BB7  
3671 - Hillingdon  
Proposed Disabled Refuge Locations  
BB-DRC-3671-02  
10<sup>th</sup> January 2020  
Review by: Thomas Gibbins  
Authorised by: Dane Owen

**5 Building 4 - Sixth Floor Plan**  
1 : 200

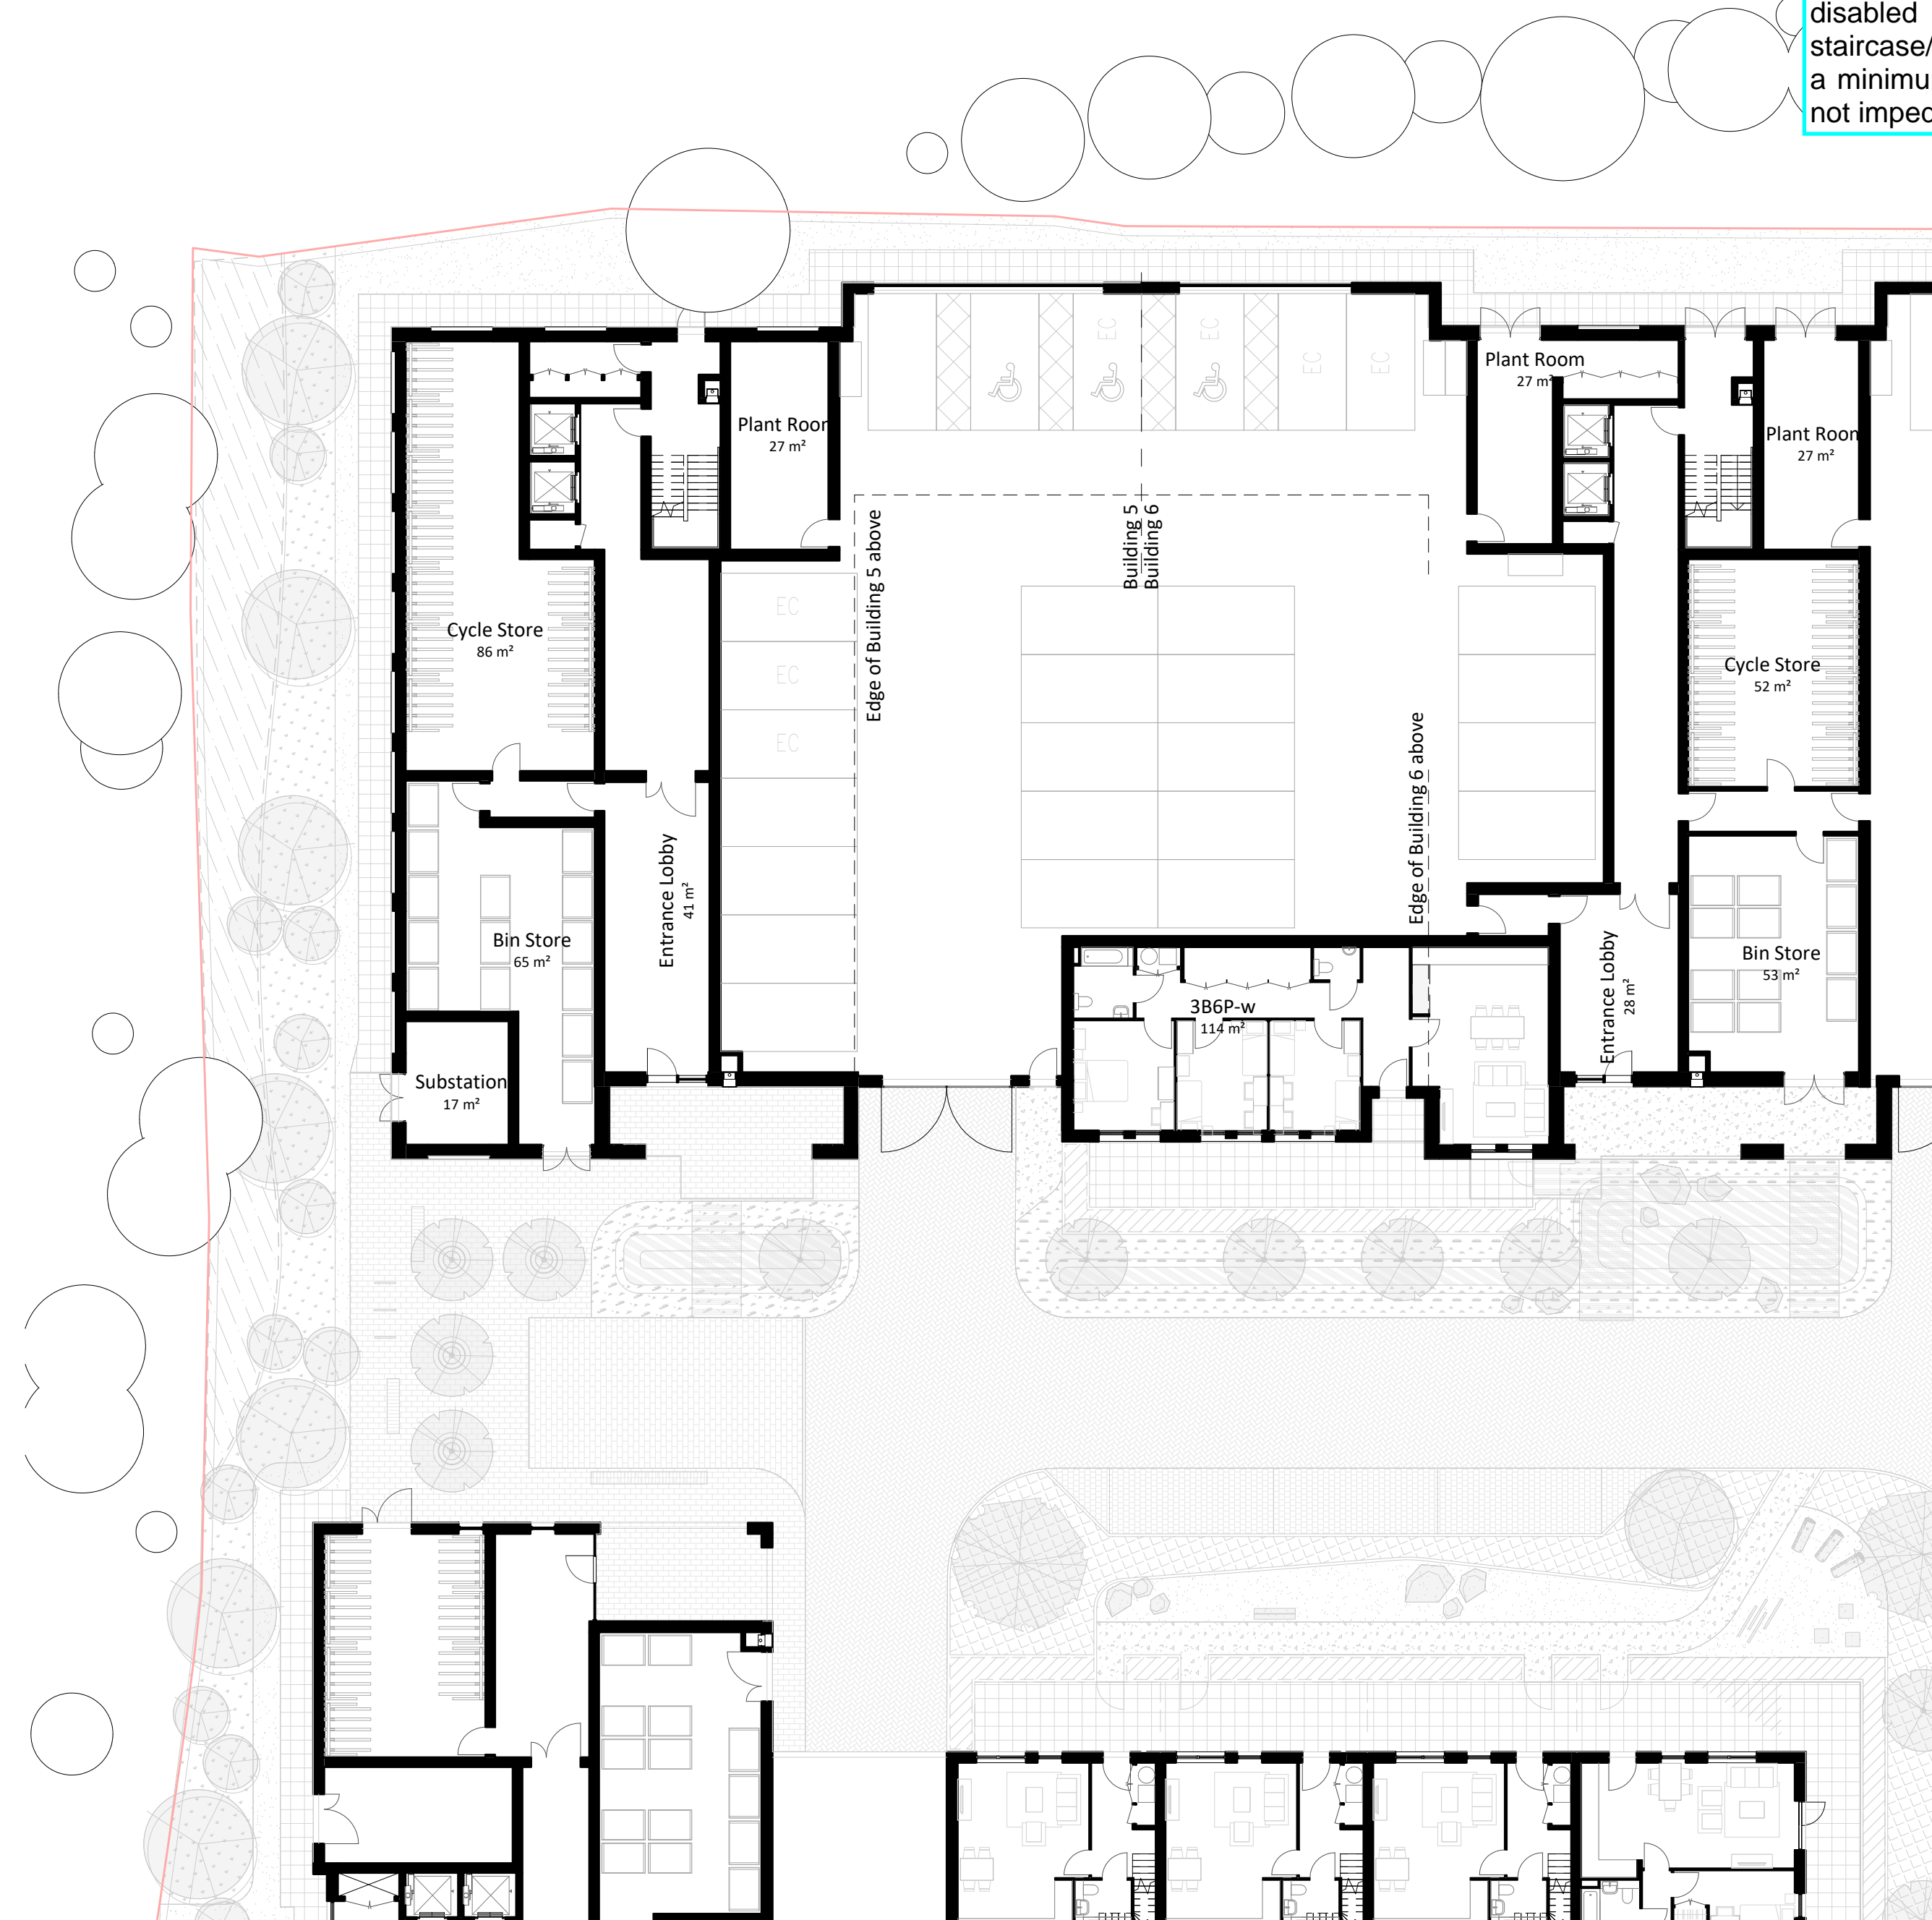
It is understood that the roof terrace is to be used by the residents (i.e. not maintenance only), therefore it's a risk that a disabled guest may be present in a fire scenario. As such, until agreed to be omitted at the detailed design stage, it is recommended that on this level a disabled refuge is allowed for in the staircase/lobby. Disabled refuges are to be a minimum 1400mm by 900mm and are to not impede the escape route.

**5 Building 5 - Roof Plan**  
1 : 200

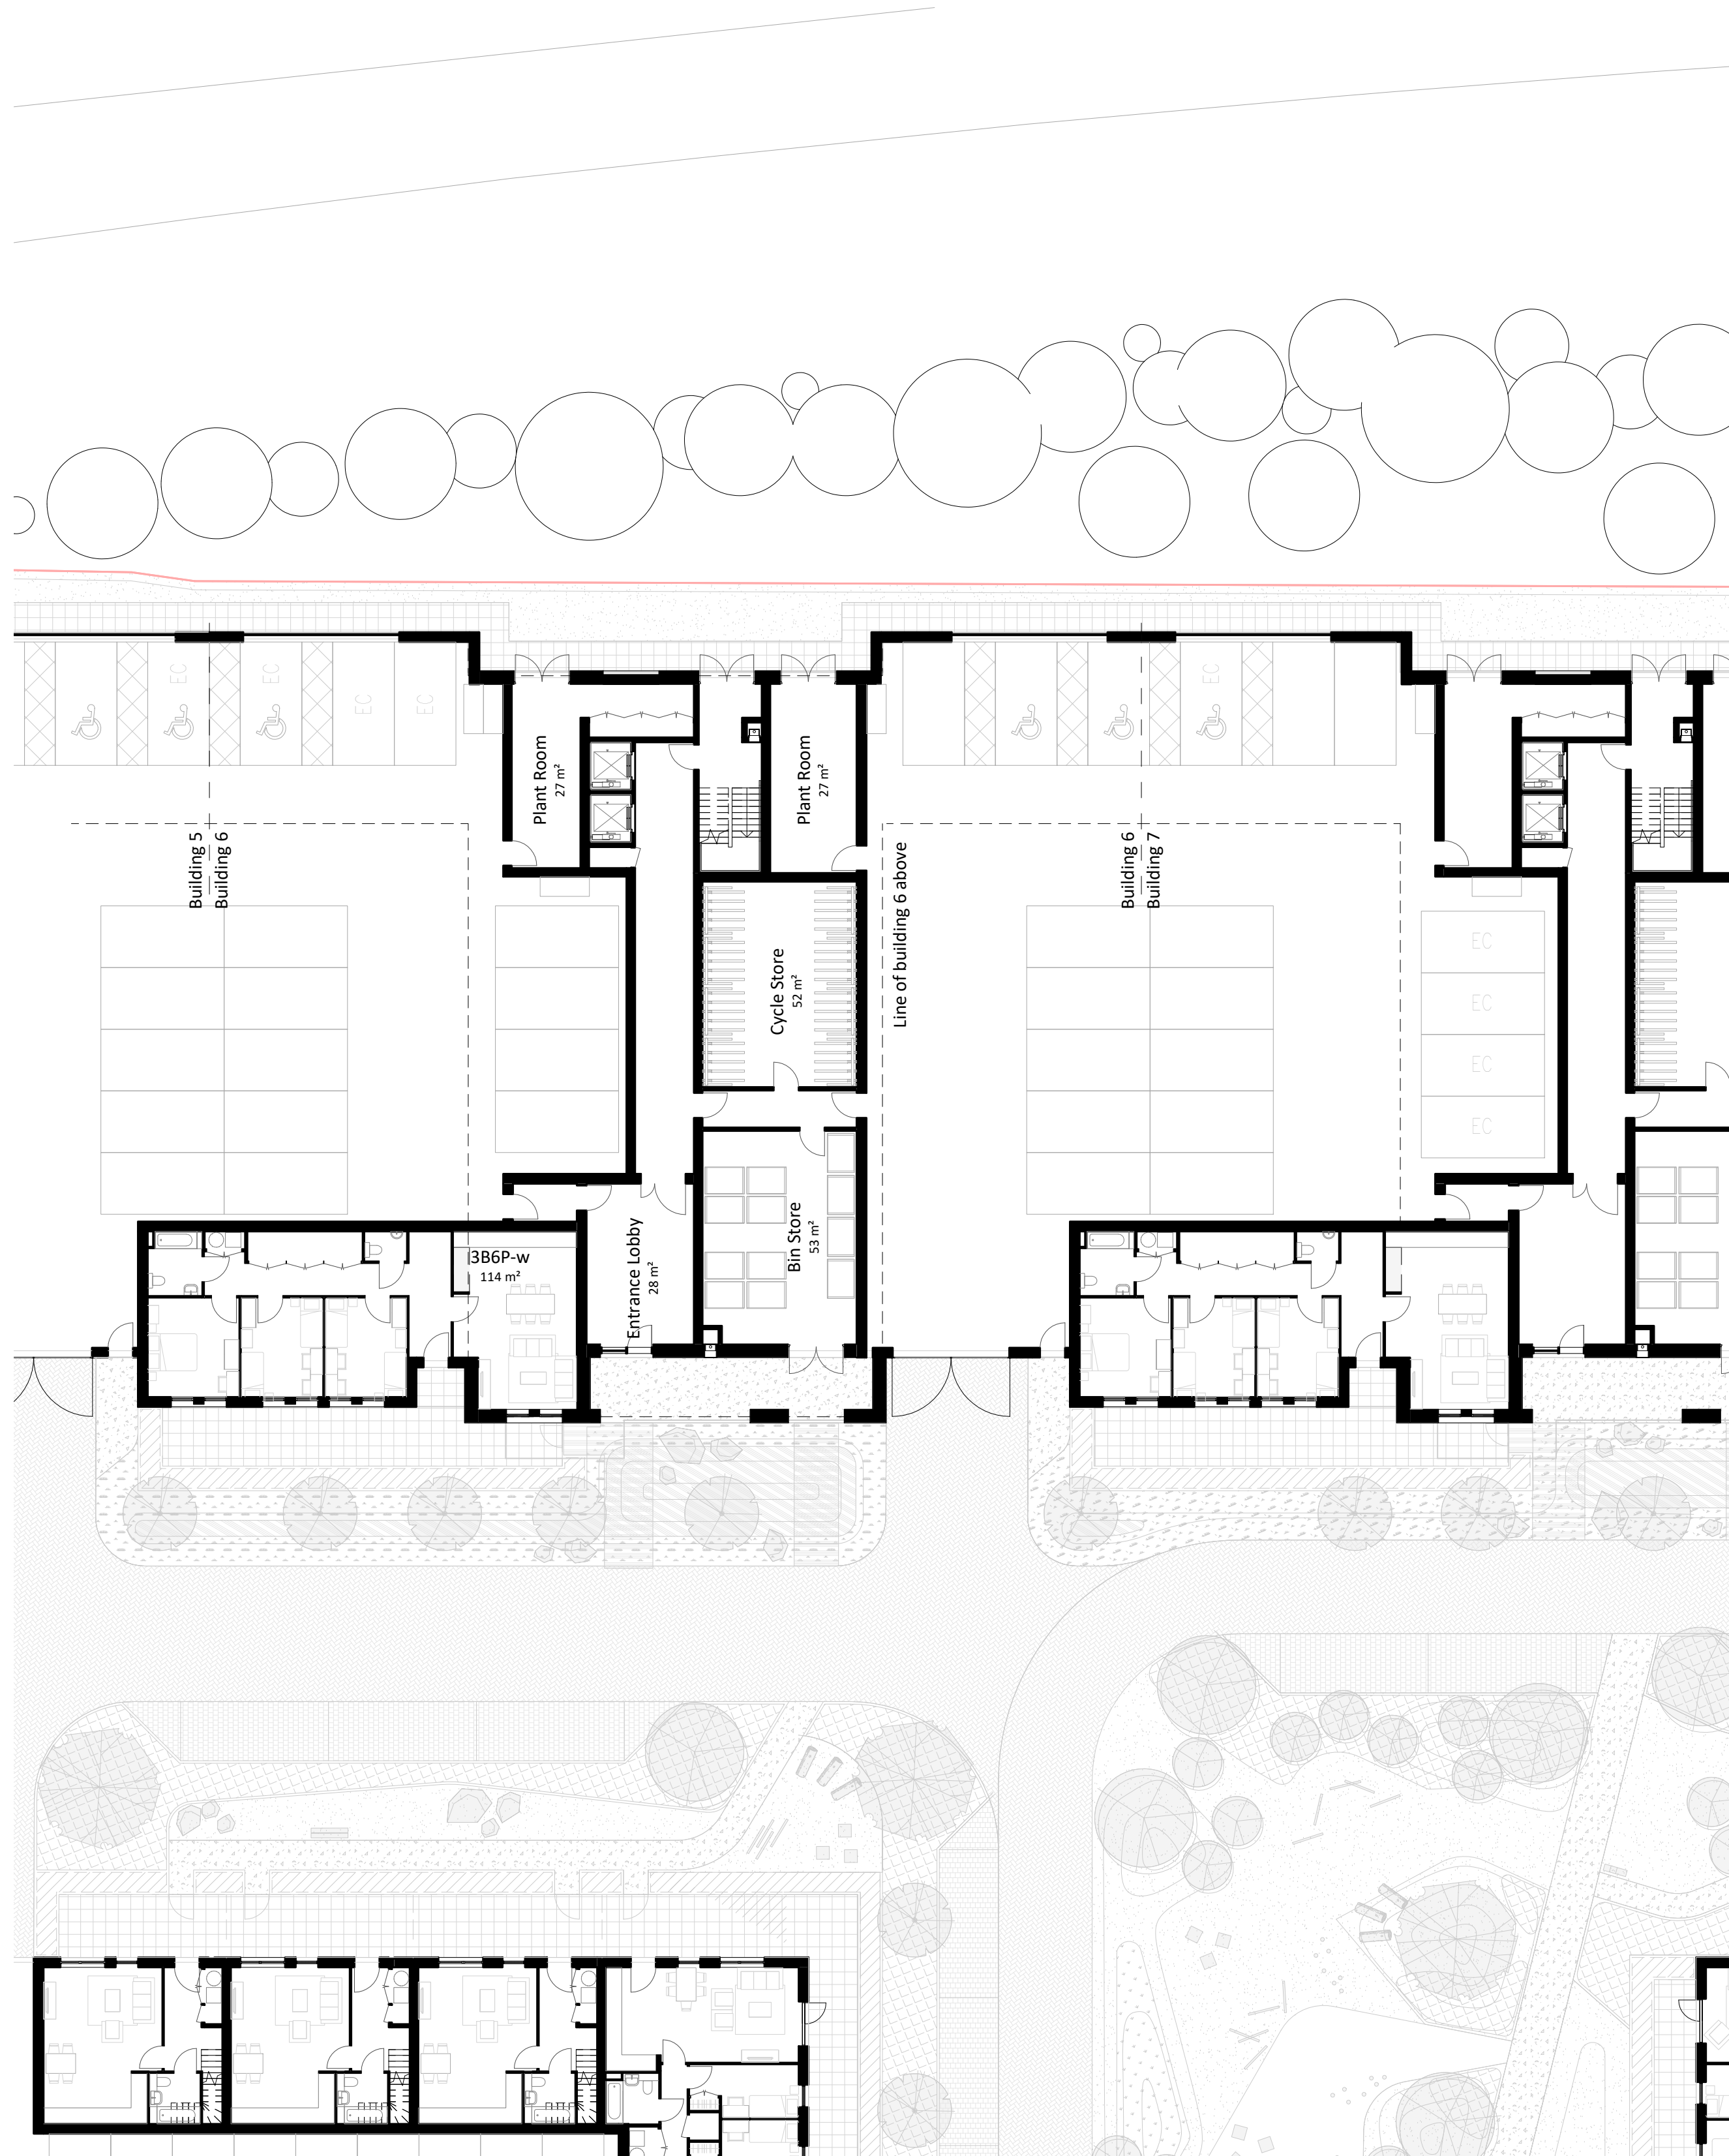
To be noted, if the roof terrace is to be used by the residents (i.e. not maintenance only), there is a risk that disabled guest may be present in a fire scenario. As such, until agreed to be omitted at the detailed design stage, it is recommended that on this level a disabled refuge is allowed for in the staircase/lobby. Disabled refuges are to be a minimum 1400mm by 900mm and are to not impede the escape route.

**5 Building 6 - Roof Plan**  
1 : 200

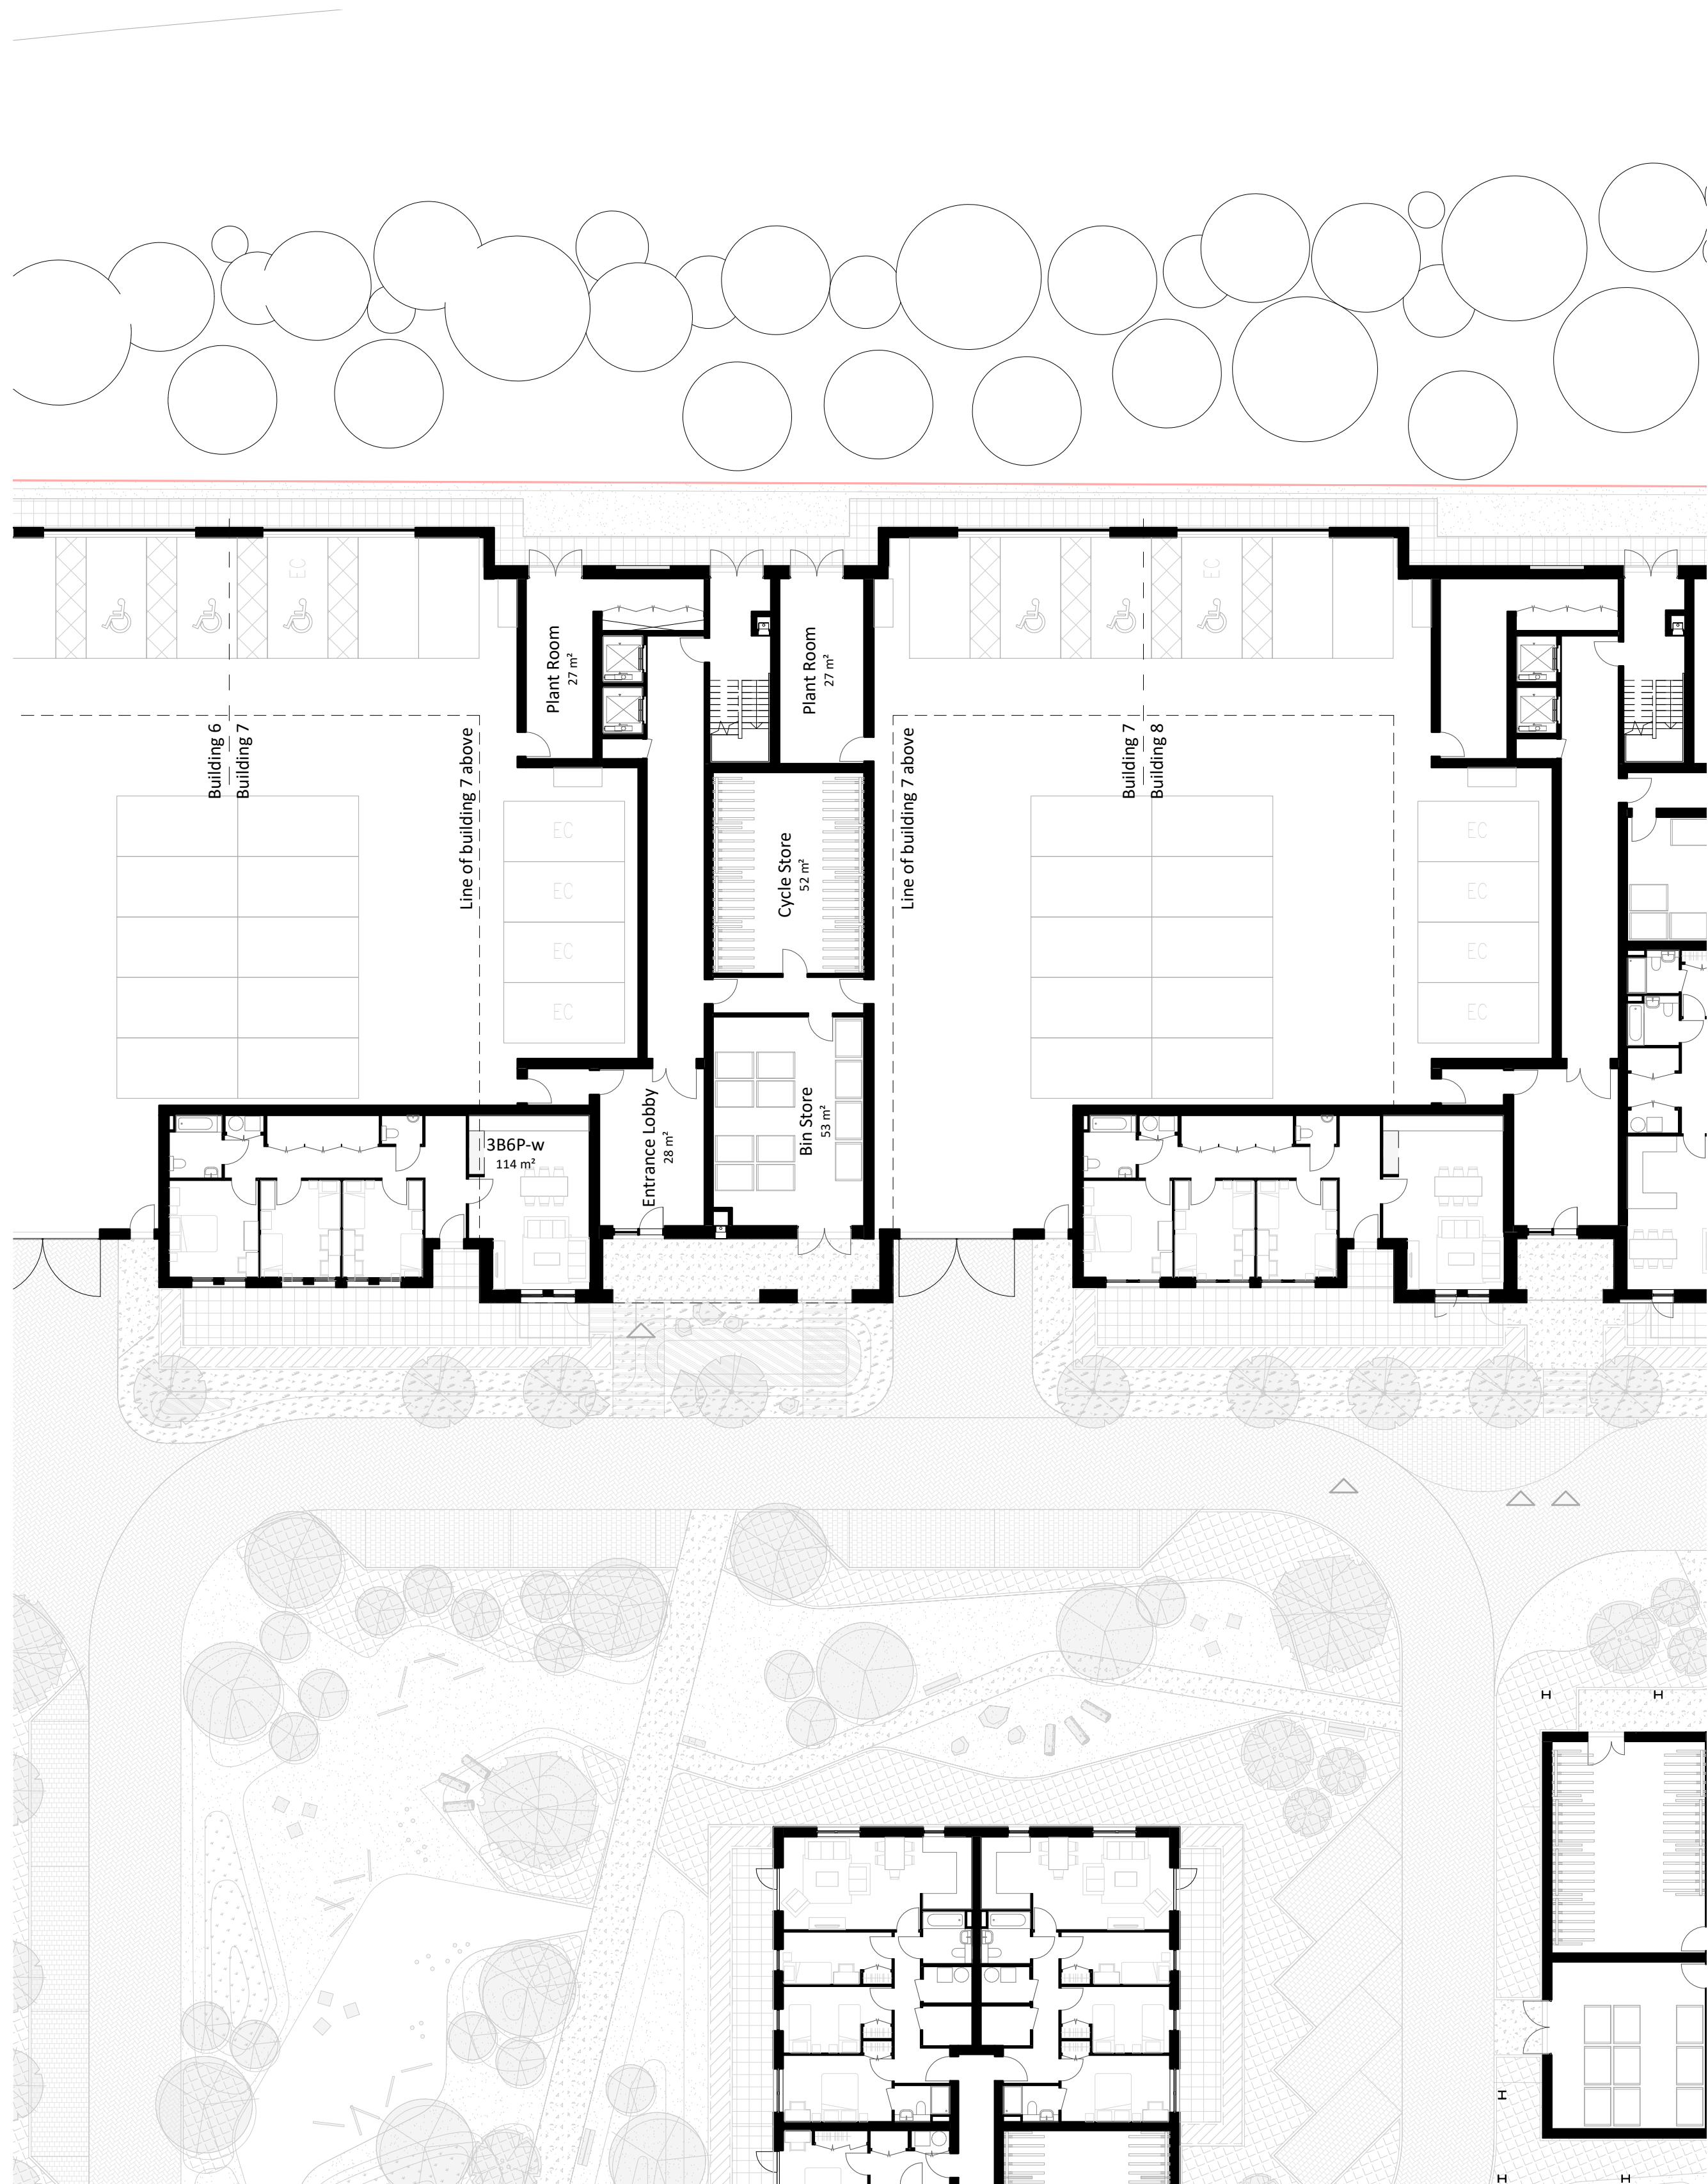
**2** To be noted, if the roof terrace is to be used by the residents (i.e. not maintenance only), there is a risk that disabled guest may be present in a fire scenario. As such, until agreed to be omitted at the detailed design stage, it is recommended that on this level a disabled refuge is allowed for in the staircase/lobby. Disabled refuges are to be a minimum 1400mm by 900mm and are to not impede the escape route.
